Town of Ridgeland

PROJECT: James F. Taylor Drive Phase I Ditch Improvements Project
(TOR-2018-01)

ADDENDUM: One (1)

DRAWING NUMBER
C-1

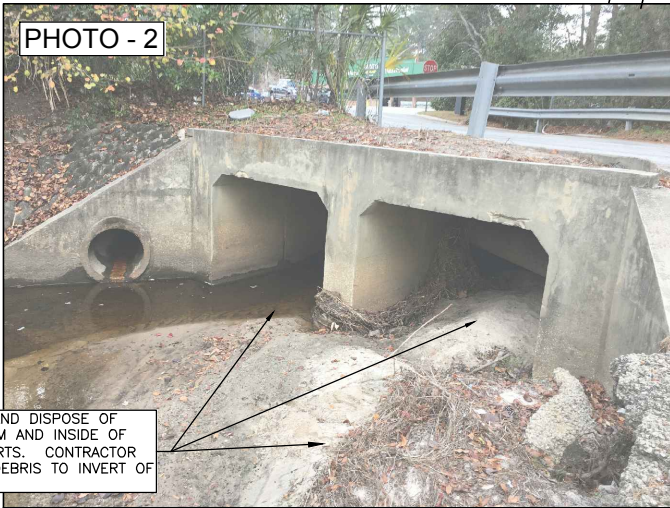
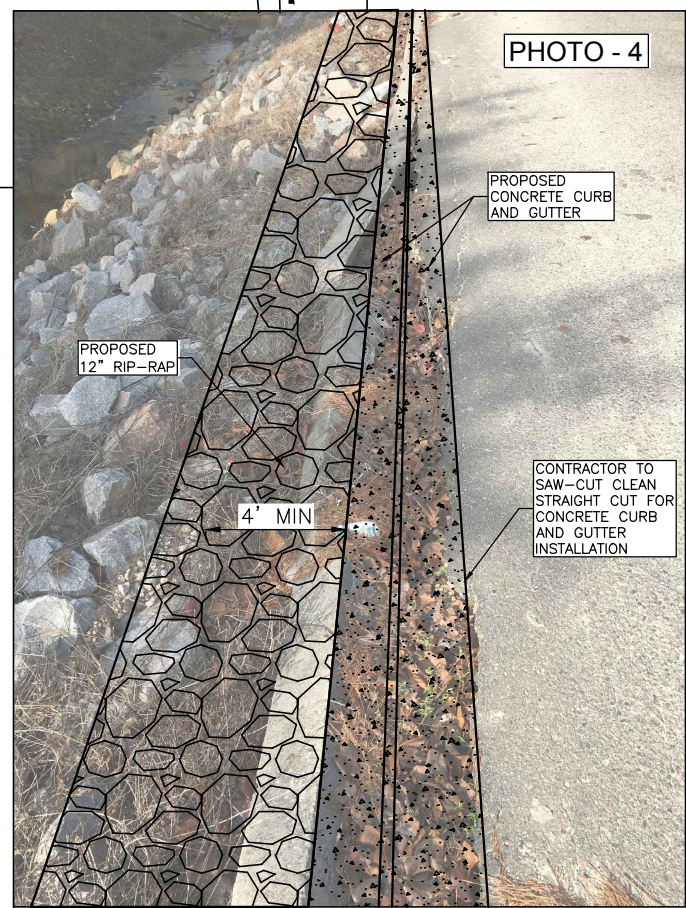
Sheet C-1 is updated to call out required fill for the exposed area to the south of the guardrail. The costs are to be include in Item 4, "Clearing and Grading, including required fill material" of the Bid Form.

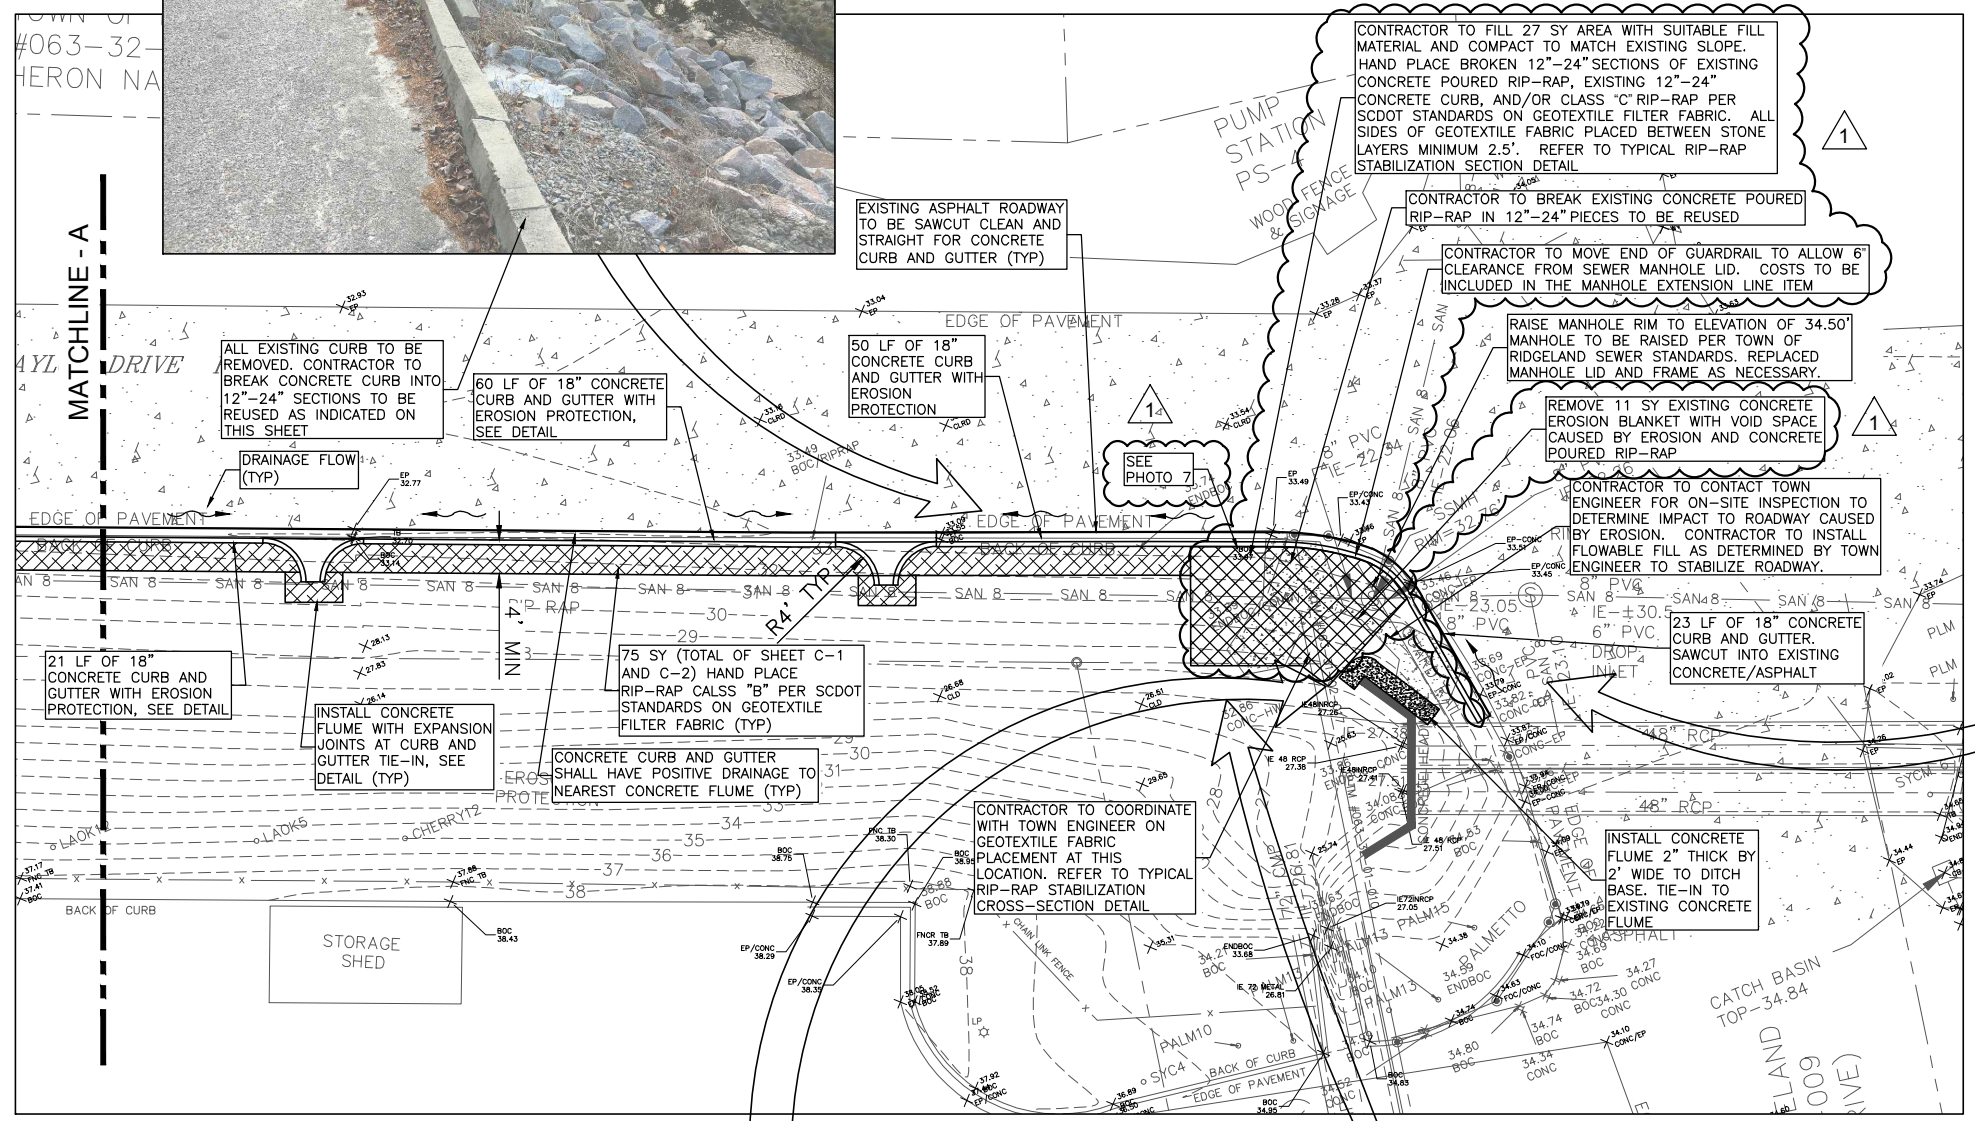
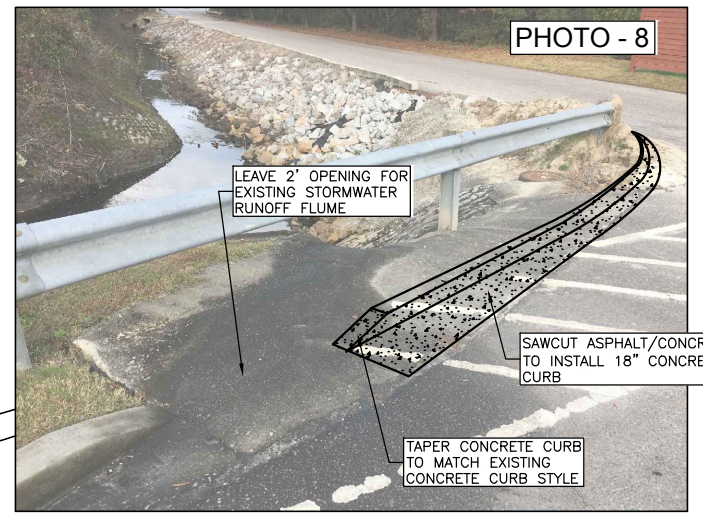
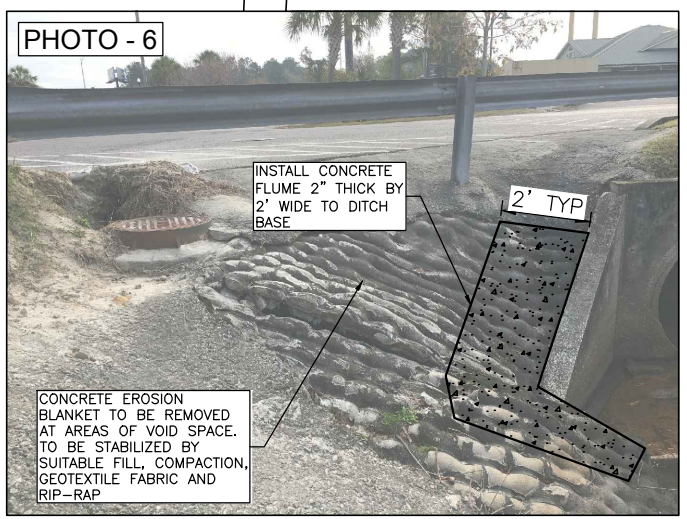
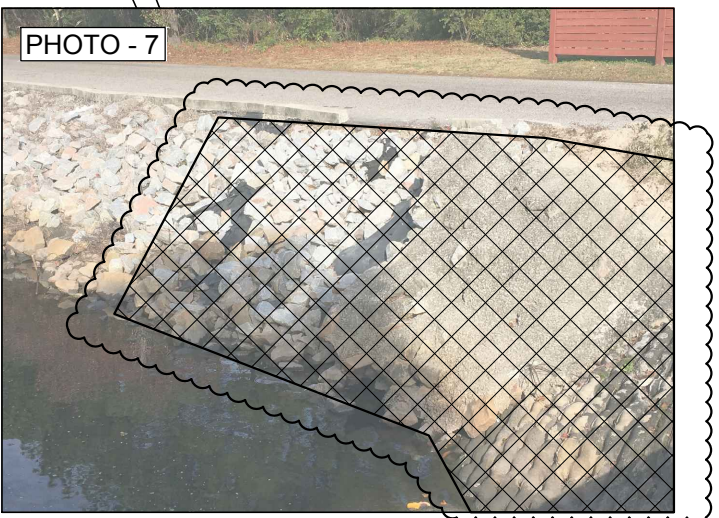
Sheet C-2 is updated to call out the additional demolition of existing concrete and installation of rip-rap protection. The Bid Form is updated to include the revised quantities.
